**TRAFFIC AND PARKING IMPACT ASSESSMENT OF  
MIXED-USE DEVELOPMENT  
AT 28 LOCKWOOD AVENUE, BELROSE**

**Development Type:**        **Mixed-Use Development**

**Site Address:**            **28 Lockwood Avenue, Belrose**

**Document reference:**    **210075.05FA**

**FIGURE 4: GLENROSE PLACE ROUNDABOUT CONCEPT**

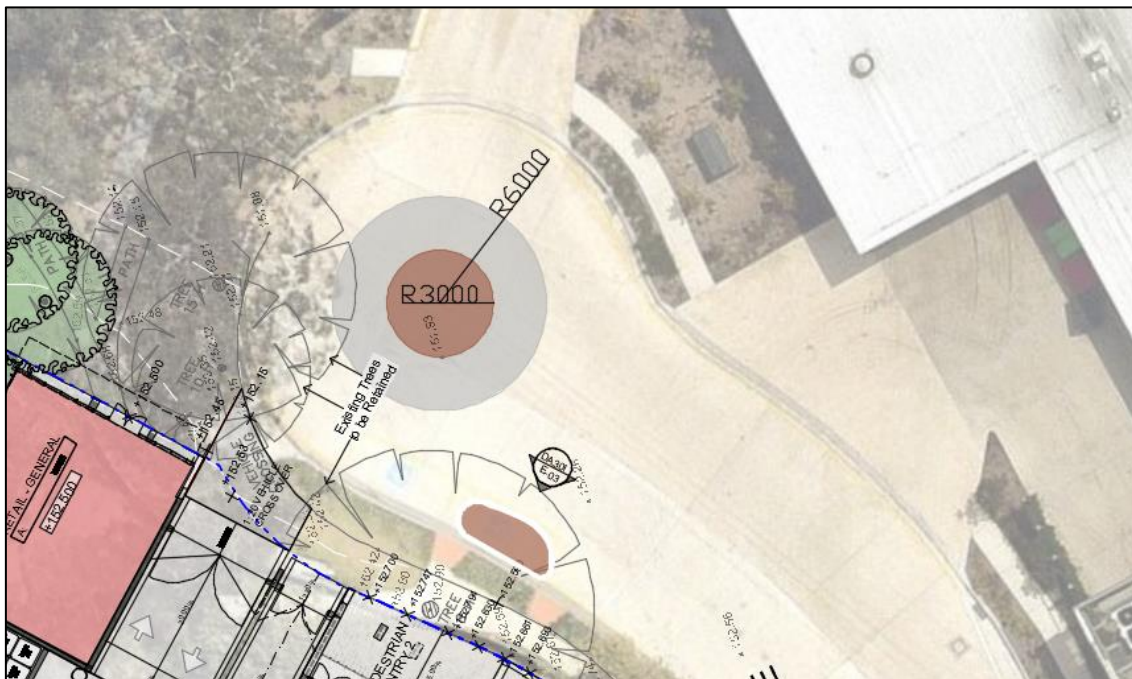
*Vehicular access to the car park is proposed via separated one-way driveways from Glenrose Place. This would be considered acceptable subject to the provision of detail design of the roundabout proposed at the cul-de-sac as well as the provision of separated vehicular access for service vehicles as explained later in the assessment comments.*

**MTE Response:** A concept design for the proposed roundabout is provided in **Annexure D**. This concept provides adequate turning facilities for the design vehicle, which is a 12.5m length Heavy Rigid Vehicle. The detailed design of the roundabout is for others to address under a condition of consent.

**FIGURE 6: HRV SWEPT PATHS OVERLAID ONTO A PEDESTRIAN REFUGE**

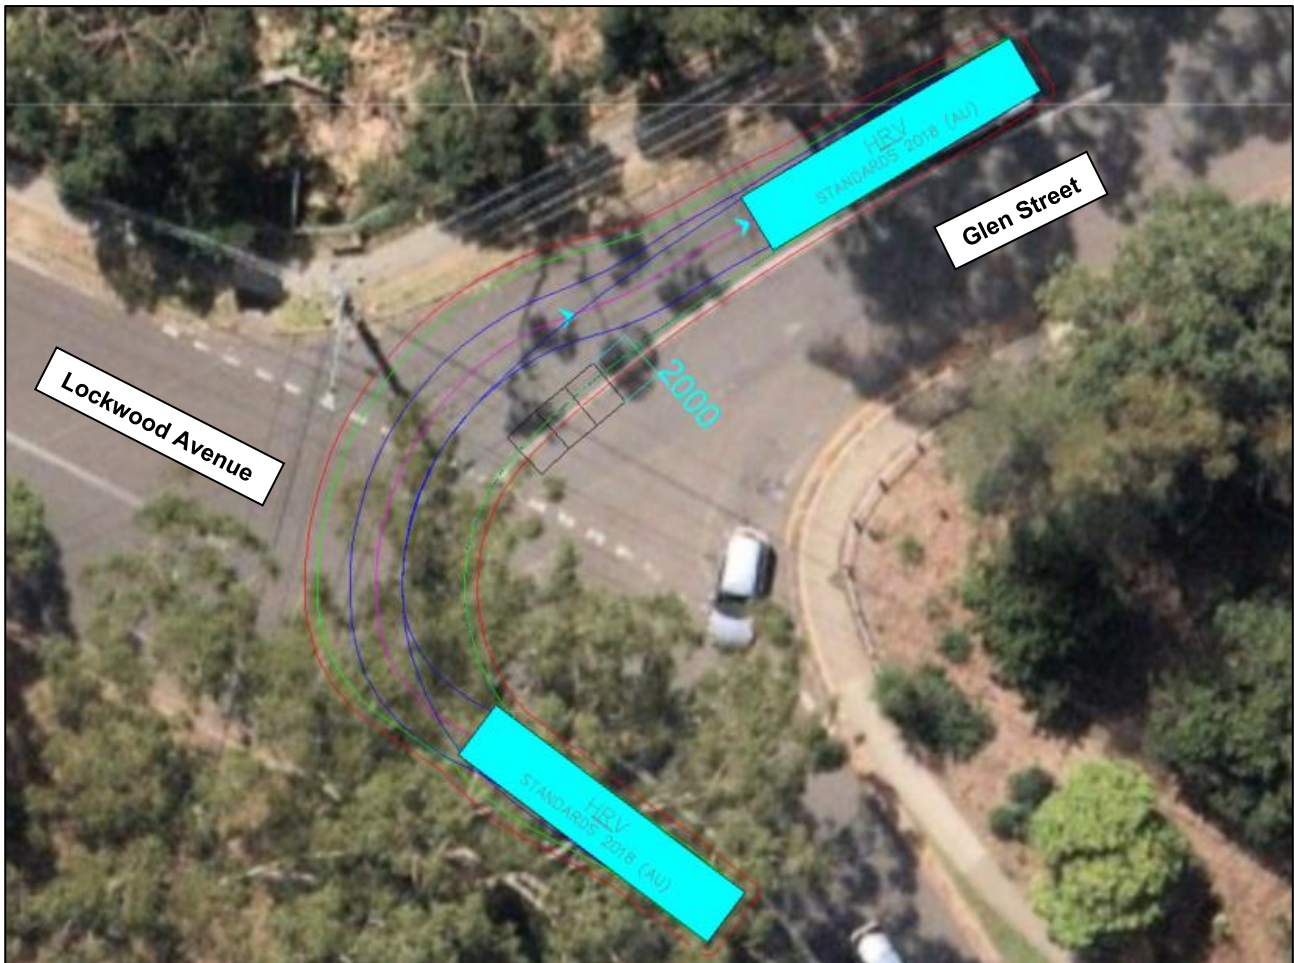
Pedestrian refuge island on Glen Street at its intersection with Lockwood Avenue

Glenrose Village has a supermarket which serviced by HRVs. Swept path analysis has been completed showing a 12.5m length HRVs turning right onto Glen Street from Lockwood Avenue. MTE has overlaid a 2m width pedestrian refuge island on an aerial image. This is the minimum pedestrian refuge width in accordance with *Figure 7 of AS1742.10*. The swept path tests of the HRV on this aerial are shown in **Figure 6**.

As shown, the HRV paths conflict with the pedestrian refuge which Council has requested. If a pedestrian refuge were to be installed in this location, it would prohibit delivery vehicles from arriving to the proposed development and Glenrose Village from this direction.

**FIGURE 8: LOCKWOOD AVENUE SSD TO EXISTING PEDESTRIAN CROSSING**

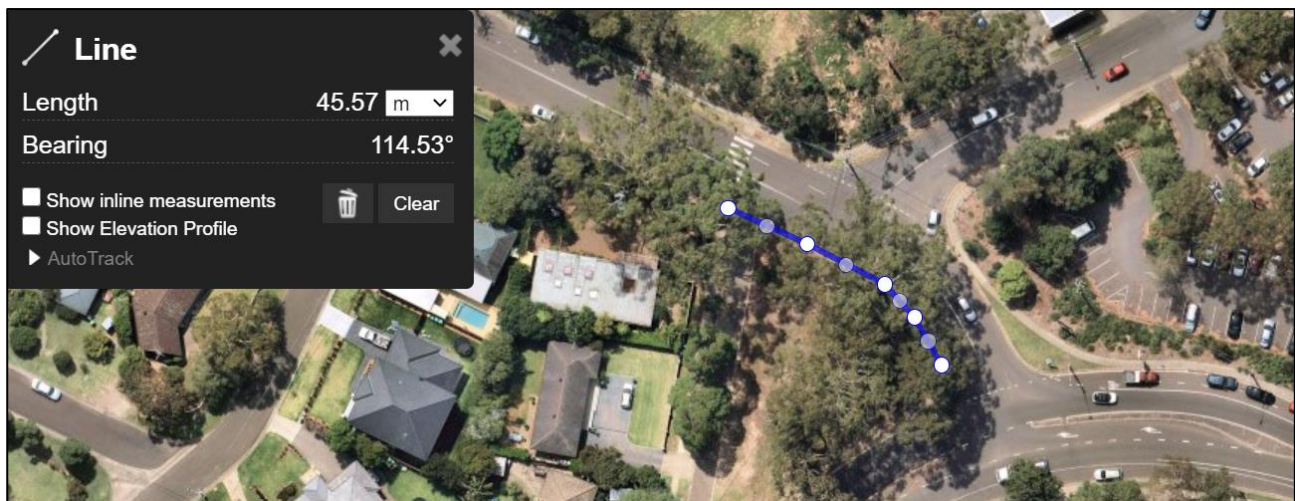
#### Raised Pedestrian Crossing on Lockwood Avenue

AS1742.10 provides the relevant standards for pedestrian control and protection, including zebra and wombat crossings. In terms of warrants, there is no difference between a raised pedestrian crossing (wombat) and an at-grade pedestrian crossing (zebra). AS1742.10 states the following with reference to the difference between wombat and zebra crossings.

Lockwood Avenue to the west of the existing pedestrian crossing is flat and has no horizontal curves. Therefore, there is excellent sight distance to the crossing from Lockwood Avenue's western approach. Lockwood Avenue's eastern approach to the crossing has a horizontal curve but provides approximately 45m of stopping sight distance (SSD) to the crossing. This is a compliant SSD for vehicles traveling up to 47km/h in accordance with *Austrroads Guide to Road Design*. As shown in **Figure 8**, a driver will be alert, having just turned onto Lockwood Avenue. A vehicle is highly unlikely to be traveling at 47 km/h or faster at this location. Therefore, the sight distances to the existing zebra crossing are satisfactory.
